April 24, 2018

**20-400 CRC Dimensional Differences**

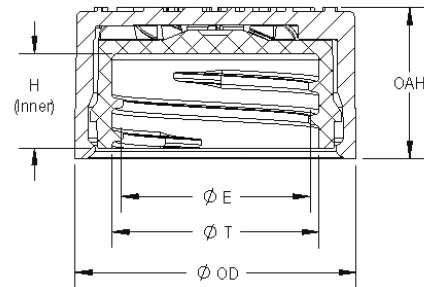
The 20mm Child Resistant Closure (CRC) design was recently updated. The following dimensional changes are the results of the product design enhancements.

<b>Old Design</b>	<b>New Design</b>	
<b>E</b>	0.719 ±0.010	0.704 ±0.010	-0.015
<b>T</b>	0.792 ±0.010	0.786 ±0.010	-0.006
<b>H</b>	0.357 ±0.010	0.360 ±0.008	0.003
<b>OD</b>	1.015 ±0.010	1.070 ±0.010	0.055
<b>OAH</b>	0.598 ±0.010	0.575 ±0.010	-0.023
<b>Weight</b>	2.6 ±1.00	3.47 ±0.50	0.870
